Staff Report

Item: 300 [S.] Woodland Ave, "Chick-fil-A" (DR 22-26)

Design Review DR 22-26 (Type III) for proposed site development of a Chick-fil-A fast food restaurant with drive-throughs and Variance VAR 22-15 for a request to exceed *maximum* off-street parking of 23 stalls by 20 stalls to have 43 stalls total: Commission decision.

Exhibit D8 Sheet C5.1 Fire access plan excerpt

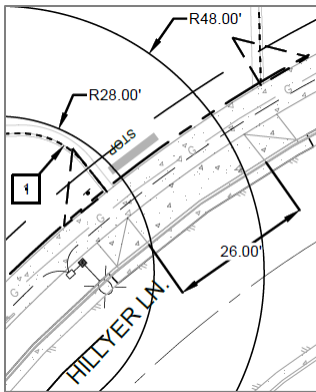
D8. Driveway max width: To conform with WDO Table 3.04A maximum regarding paved width of two-way driveways in a commercial context, the developer shall revise the site and composite utility plans – or equivalent sheets within a building permit application plan set through the Building Division and/or a civil engineering review application civil plan set through the PW Engineering Division – either to illustrate and dimension the approach, apron, curb cut, or ramp of the middle of the three driveways (Driveway 2) at 24 ft max width or to document if and how Table 3.04A footnote 7 about Woodburn Fire District OFC administration is applicable. For the latter, documentation shall include at least either (a) a letter or equivalent from the District or (b) revision of the fire access plan, which Exhibit D8 excerpts, to narrow the driveway to that necessary to accommodate the illustrated fire apparatus outside turning radius and to dimension the narrowed driveway apron. If through building permit review, then this is due prior to issuance, or if through civil engineering plan review, then due prior to ODOT or PW issuance of an approved civil plan set.

Exhibit Woodland parking lane

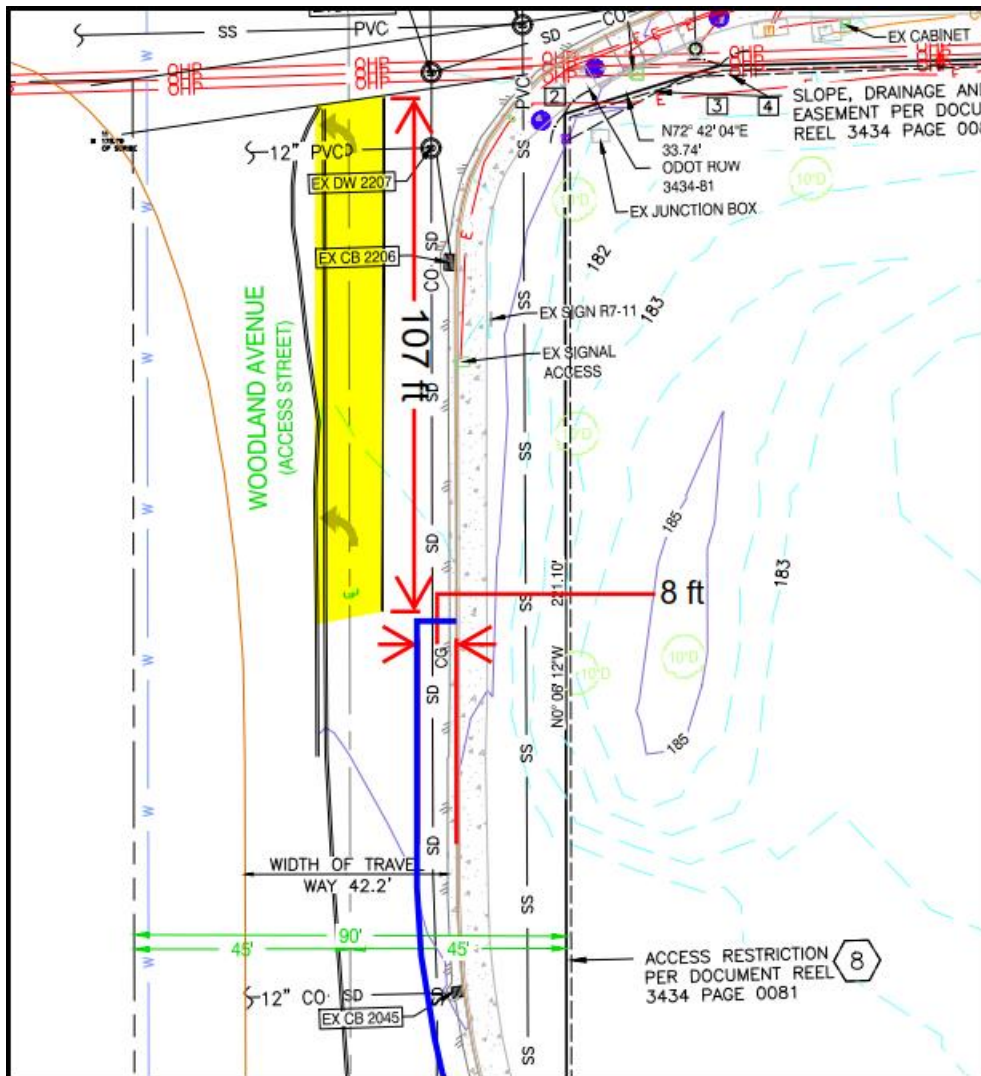
Based on an applicant e-mail to the Director June 6, 2023 at 12:02 p.m., assume that ODOT would direct that a parking lane not extend north of the start of the left turn lane right white stripe, a distance of approximately 107 ft per the following colored diagram that the e-mail included:

At a south, a parking lane would not extend within 20 ft of Hillyer (about in line with the north side of the unmarked “crosswalk” as ORS 801.220 defines) per ORS 811.550(17) and the 801.220 definition. The west property boundary spans approximately the distance between crosswalks and is approximately 248 ft. $248 - (107 + 20) = 121$. The conventional length of an on-street parallel parking space is 22 ft. $121 / 22 = 5.5 \rightarrow 5$ parking spaces. The developer shall provide a parking lane minimum extent $5 \times 22 = 110$ ft total. For each reduction of area that reduces parking spaces to a lower integer when rounded, the developer shall pay a conditioned fee in-lieu. Staff calculates:

- b. Woodland: Regarding a parking lane, the developer shall:
 - (1) Provide a parking lane minimum extent 110 ft (equal to five 22-ft long spaces); or
 - (2) Provide a parking lane of lesser extent per subsection d3 below, and pay a fee in lieu of omitted spaces.

Exhibit D8 Sheet C5.1 Fire access plan excerpt

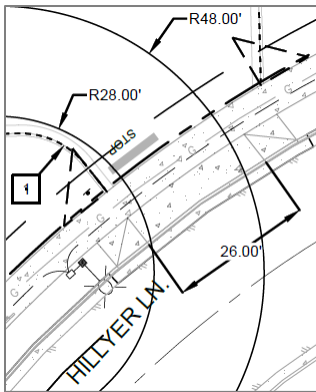
D8. Driveway max width: To conform with WDO Table 3.04A maximum regarding paved width of two-way driveways in a commercial context, the developer shall revise the site and composite utility plans – or equivalent sheets within a building permit application plan set through the Building Division and/or a civil engineering review application civil plan set through the PW Engineering Division – either to illustrate and dimension the approach, apron, curb cut, or ramp of the middle of the three driveways (Driveway 2) at 24 ft max width or to document if and how Table 3.04A footnote 7 about Woodburn Fire District OFC administration is applicable. For the latter, documentation shall include at least either (a) a letter or equivalent from the District or (b) revision of the fire access plan, which Exhibit D8 excerpts, to narrow the driveway to that necessary to accommodate the illustrated fire apparatus outside turning radius and to dimension the narrowed driveway apron. If through building permit review, then this is due prior to issuance, or if through civil engineering plan review, then due prior to ODOT or PW issuance of an approved civil plan set.

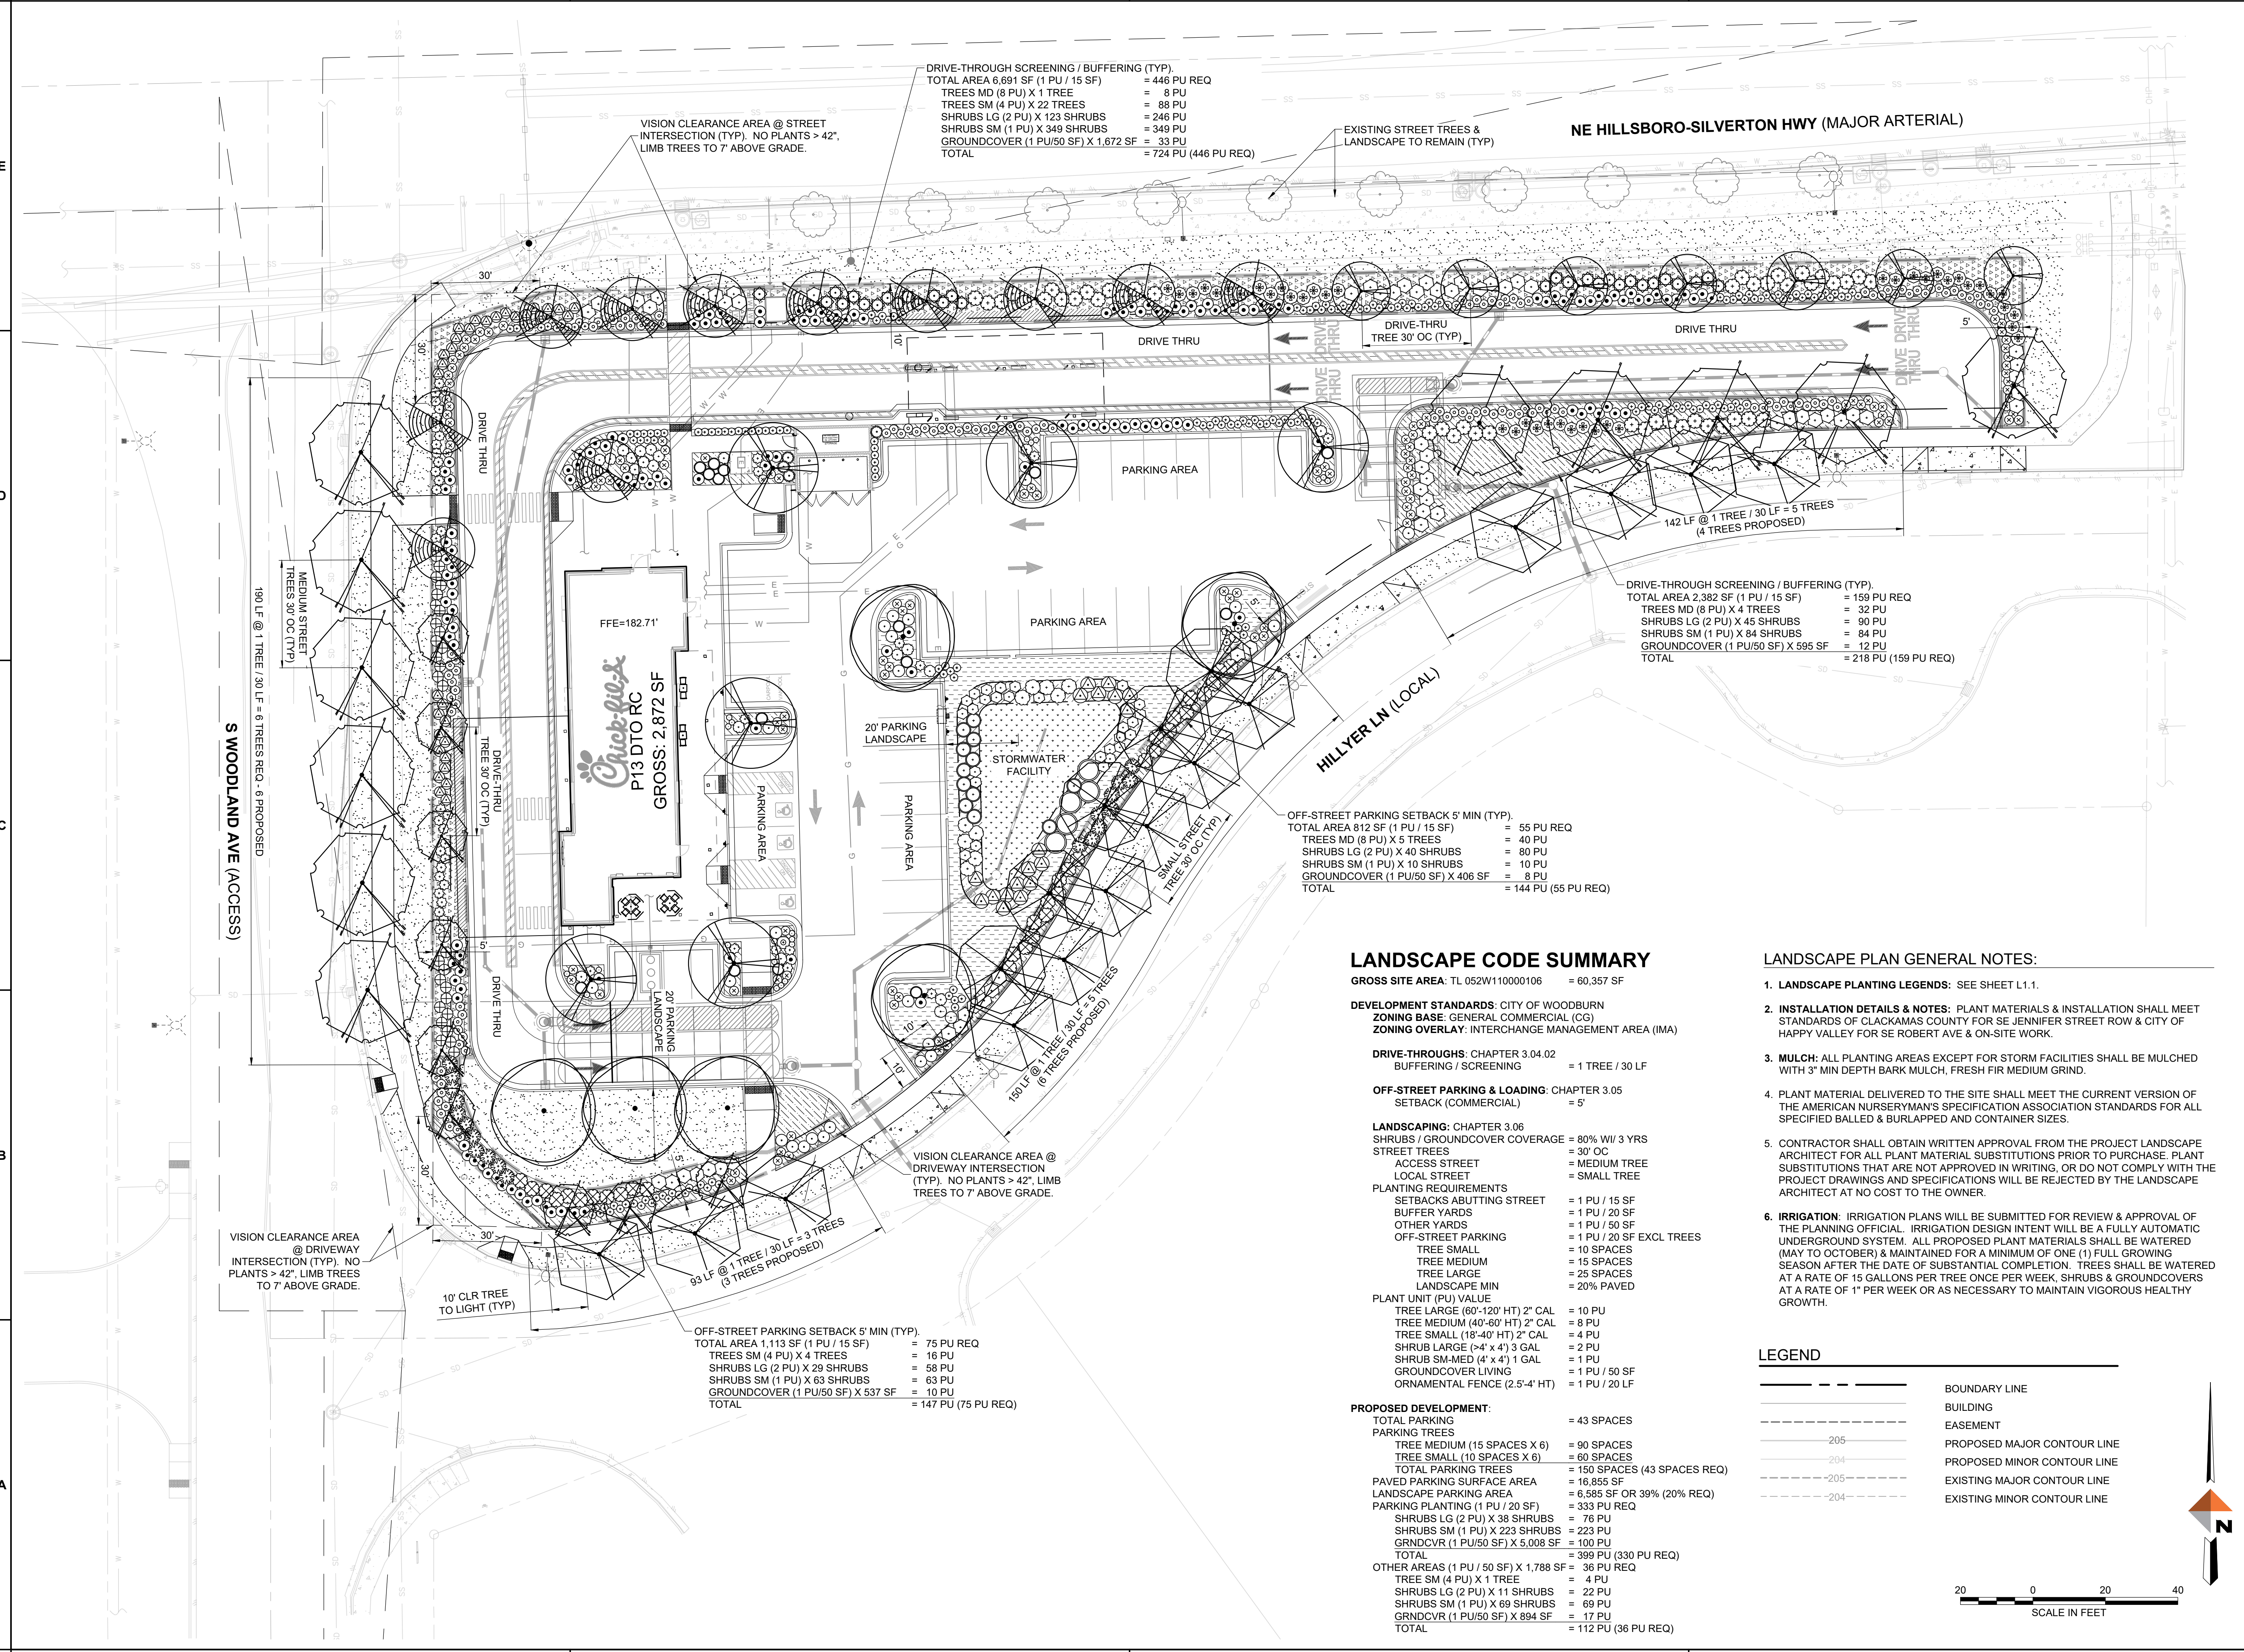
D12. Landscaping notes: To conform with WDO 3.06.02J, the developer shall revise landscape plan Sheet L1.0 general note 2 to correct jurisdictional references prior to building permit issuance.

- LANDSCAPE PLANTING LEGENDS: SEE SHEET L1.1.
- INSTALLATION DETAILS & NOTES: PLANT MATERIALS & INSTALLATION SHALL MEET STANDARDS OF CLACKAMAS COUNTY FOR SE JENNIFER STREET ROW & CITY OF HAPPY VALLEY FOR SE ROBERT AVE & ON-SITE WORK.
